Contract #: 04-0120F4
 Cty: SF/ALA Rte: 80 PM: 13.2/13.9
 File #: 69.25B

QUALITY ASSURANCE -- NON-CONFORMANCE REPORT

Location: Changxing Island, Shanghai, P.R. China **Report No:** NCR-000935
Prime Contractor: American Bridge/Fluor Enterprises, a JV **Date:** 09-Dec-2010
Submitting Contractor: Zhenhua Port Machinery Company, Ltd (ZPMC), Changxing Island **NCR #:** ZPMC-0896

Reference Description: North Tower Lift 5 Cover Plate Re-Installed Not in accordance to Approved Shop Drawing

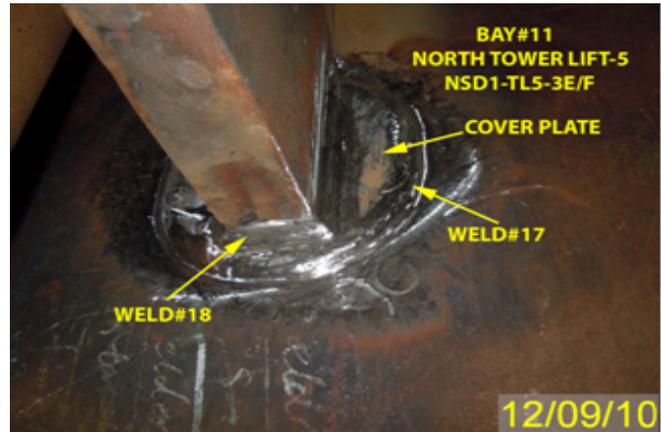
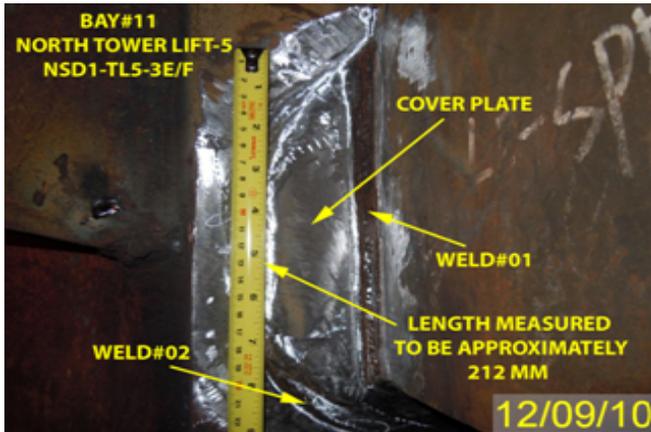
During the Caltrans Quality Assurance (QA) in-process observation on North Tower Lift 5 Cover plate, this QA Inspector discovered the following issue:

- ZPMC fabrication personnel removed 2 cover plates involving a total four (4) Non-SPCM fillet welds without notifying the Engineer .
- ZPMC re-welded with new cover plates, where the dimension of the cover plates does not comply with the approved drawings.
- As per the shop drawing the required length of the cover plate is 151.4 mm. The length measured was approximately 212 mm.
- Welds are fillet welds joining cover plate to skin 'E'.
- The weld designations are NSD1-TL5-3E/F#01; 02; 17; 18.
- This component located at fabrication Bay#11.
- NCR ZPMC-827 had been issued on 10/19/2010 for the two non-conforming cover plates that were removed. Response to this NCR is still outstanding todate.

AWS D1.5 2002 Section 3.7.5: "The Engineer shall be notified before improperly fitted and welded members are cut apart".

Reference Description: Lift 5: North Grillage Cover Plate dimension for Longitudinal Grillage plate do not match with Drawing

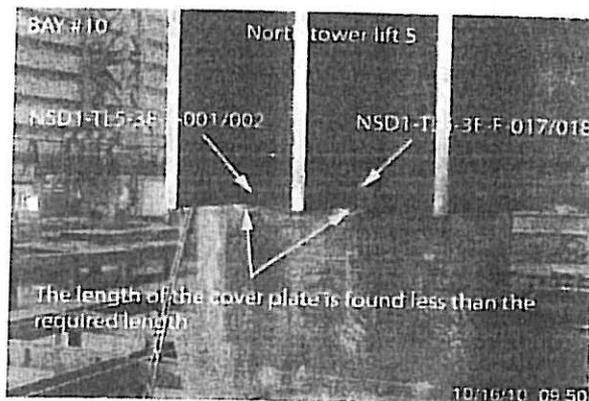
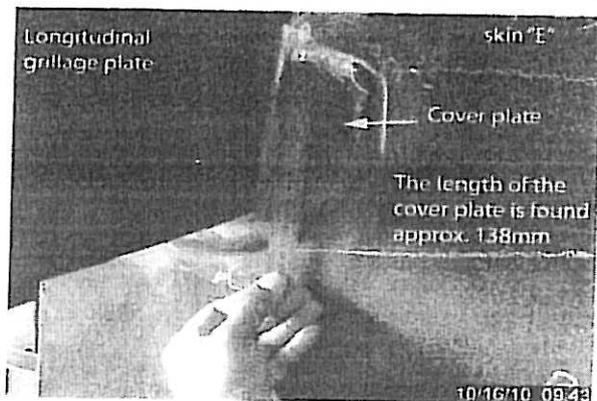
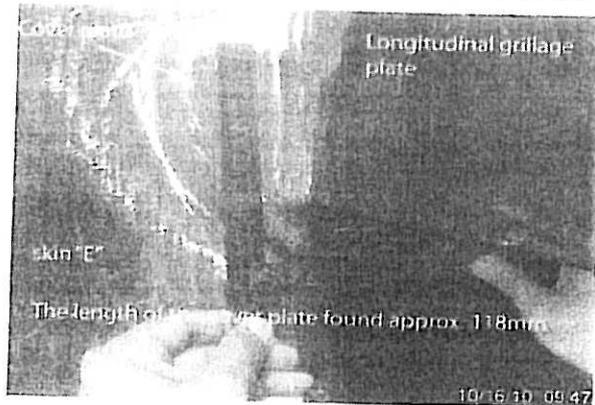
During the Quality Assurance Visual Testing (VT) verification of welds located on Cover Plate for the Longitudinal Grillage plate of North Tower lift 5, this Quality Assurance (QA) Inspector discovered the following issues:

- The dimensions of Cover Plate do not match the approved shop drawings.
- As per shop drawing the required length of the Cover Plate is 151.4mm.
- Cover Plate weld # NSD1-TL5-3E/F-001/002, the length of the Cover Plate was measured as 138mm.
- Cover Plate weld # NSD1-TL5-3E/F-017/018, the length of the Cover Plate was measured as 118mm and 143mm.
- These welds are fillet welds, joining the Cover Plate to the Skin Plate and Longitudinal Grillage plate.
- The member is located in Bay 10.

-Attached photographs provide additional location details.

Reference Description: North Tower Lift 5 Cover Plate Re-Installed Not in accordance to Approved Shop Drawing

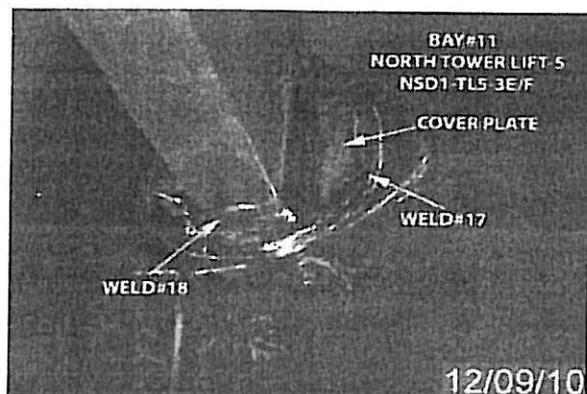
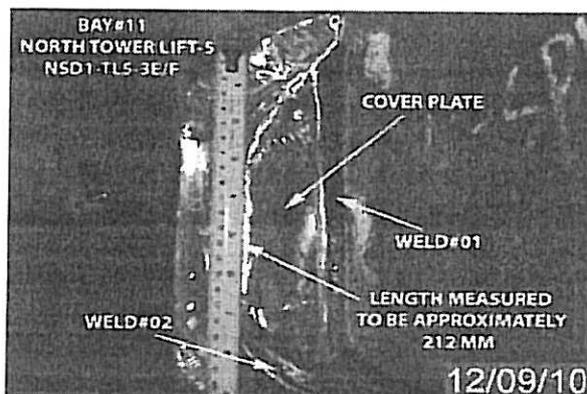
During the Caltrans Quality Assurance (QA) in-process observation on North Tower Lift 5 Cover plate, this QA Inspector discovered the following issue:

- ZPMC fabrication personnel removed 2 cover plates involving a total four (4) Non-SPCM fillet welds without notifying the Engineer .
- ZPMC re-welded with new cover plates, where the dimension of the cover plates does not comply with the approved drawings.
- As per the shop drawing the required length of the cover plate is 151.4 mm. The length measured was approximately 212 mm.
- Welds are fillet welds joining cover plate to skin 'E'.
- The weld designations are NSD1-TL5-3E/F#01; 02; 17; 18.
- This component located at fabrication Bay#11.
- NCR ZPMC-827 had been issued on 10/19/2010 for the two non-conforming cover plates that were removed. Response to this NCR is still outstanding todate.

AWS D1.5 2002 Section 3.7.5: "The Engineer shall be notified before improperly fitted and welded members are cut apart".

Reference Description: West Tower Cover Plates Re-installed without following Approved Shop Drawing

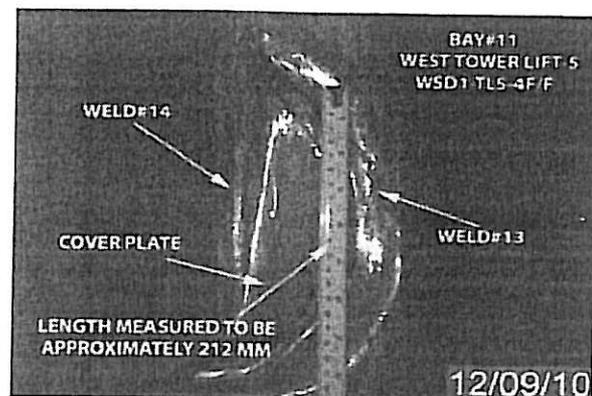
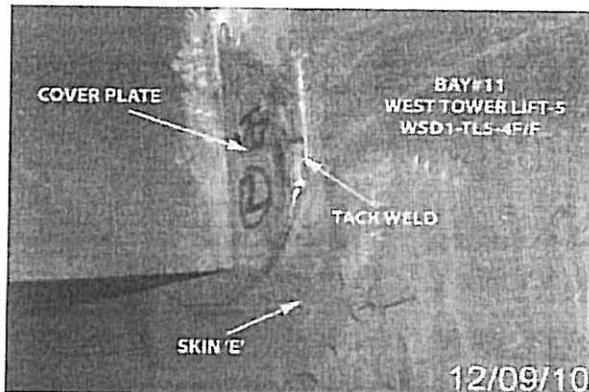
During the Caltrans Quality Assurance (QA) in-process observation on West tower lift-5 Cover plate, this QA Inspector discovered the following issue:

- ZPMC fabrication personnel removed 2 cover plates involving a total four (4) Non-SPCM fillet welds without notifying the Engineer.
- ZPMC re-welded with new cover plates, where the dimensions of the cover plates do not comply with the approved drawings.
- As per the shop drawing the required length of the cover plate is 151.4 mm. The length measured was approximately 212 mm.
- Welds are fillet welds joining cover plate to skin 'E'.
- The weld designations are WSD1-TL5-4F/F#13; 14; 15; 16.
- This component located at fabrication Bay#11.
- NCR ZPMC-827 had been issued on 10/19/2010 for the two non-conforming cover plates that were removed. Response to this NCR is still outstanding today.

AWS D1.5 2002 Section 3.7.5: "The Engineer shall be notified before improperly fitted and welded members are cut apart".

A5-1 - PL 10X190X 212.5 (A709M-345 T2)

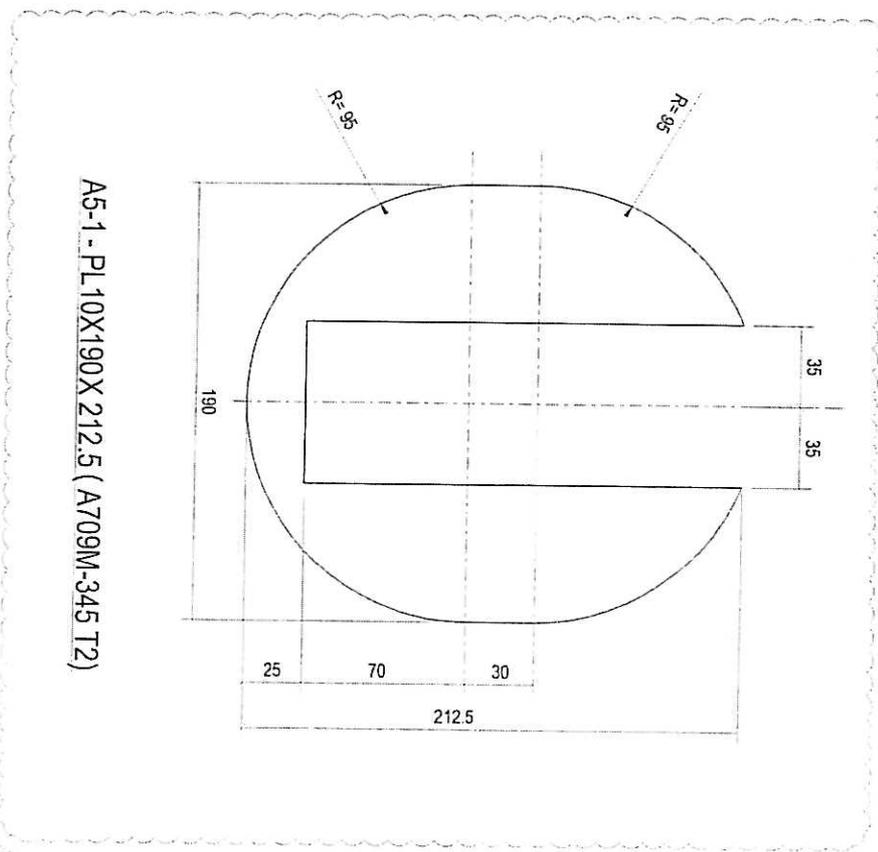
ZPMC received NCR-000865(ZPMC-0827), NCR-000935(ZPMC-0896), NCR-000936(ZPMC-0897), they all mentioned that CT inspectors found ZPMC used incorrect dimension component without prior approval by Engineer.

Here we clarify as below, as ZPMC got the oral agreement "RFF" drawing, so it was thought can be used without submitting formal documentation, but actually it should be. So it was a misapprehension, in the future we will take more care and make more communication with each other to avoid such problem. As a result the drawing was approved by Engineer and welds were accepted and green tagged.

Contractor will submit revised shop drawing as per the as built for Engineer's approval. Ensure in future to communicate with CT before any modification works are performed.

Contractor has revised the shop drawing and submitted for Engineer's approval. The revised drawing has been accepted and the cover plate left as- built.
